# Access Compliance Report Public Rights-of-Way (Curb Ramps)

Intersection ID: 9617      Main Street: CATALINA\_AV      Cross Street: W\_28TH\_ST      Location: NW

ADA ID: D308C62A8342      Ramp Type: Directional1      Initial Pass/Fail: Fail      Overall Compliance: No      Severity Score: 13.75

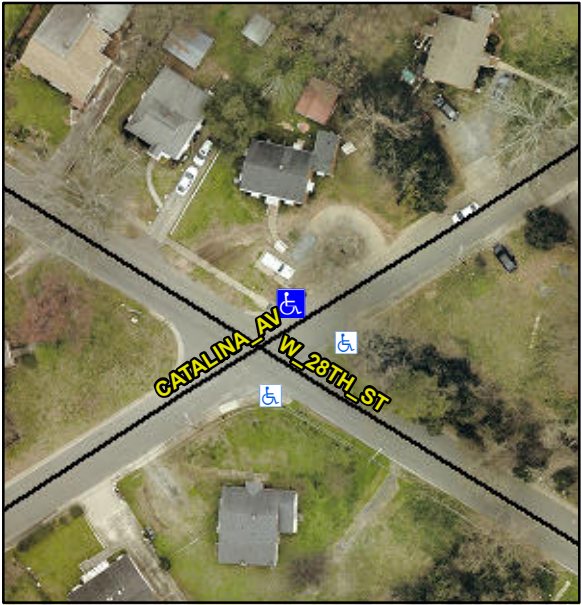
Compliance	Description	Data	Compliance	Description	Data
N/A	Ramp Length (in)	112.0	N/A	Grade Break?	N/A
Yes	Ramp Width (in)	55.0	N/A	Grade Break Slope (%)	0.0
No	Ramp Slope (%)	10.7	N/A	Grade Break XSlope (%)	0.0
No	Ramp XSlope (%)	3.6			
N/A	Flare Type LT	N/A	N/A	Flare Type RT	N/A
N/A	Flare Slope LT (%)	N/A	N/A	Flare Slope RT (%)	0.0
N/A	Flare Traversable LT?	N/A	N/A	Flare Traversable RT?	N/A
N/A	Landing Length (in)	0.0	N/A	DWS Provided?	N/A
N/A	Landing Width (in)	0.0	N/A	DWS Contrast?	N/A
N/A	Landing Slope (%)	0.0	N/A	DWS Length (in)	N/A
N/A	Landing X Slope (%)	0.0	N/A	DWS Full Width?	N/A
N/A	Landing Curb? (Y/N)	N/A	N/A	DWS Offset LT (in)	N/A
N/A	Shared Landing?	N/A	N/A	DWS Offset RT (in)	N/A
N/A	Gutter Ponding?	0.0	N/A	Gutter Slope (%)	N/A
N/A	Gutter Lip Ht (in)	0.5	N/A	Gutter X Slope (%)	N/A
N/A	Painted X Walk1?	No		Road Slope (%)	4.0
	X Walk 1 Direction	To SE		Road X Slope (%)	0.8
	X Walk 1 Width (in)	N/A		Clear Space?	N/A

X Walk 1 Slope (%)	4.0	N/A	Clear Space to XWalk (in)	N/A
	X Walk 1 X Slope (%)	0.8	N/A	Storm Grate/Utility Hazard?	N/A
N/A	Ramp inside XWalk1?	N/A		Storm Grate/Utility Type	
N/A	Any Obstructions?	N/A			N/A
	Obstruction Type		Yes	Surface Condition? (G/P)	Good
			N/A	Curb Slope (%)	13.3

Possible Solutions:  
**Remove & Replace Entire Ramp.**
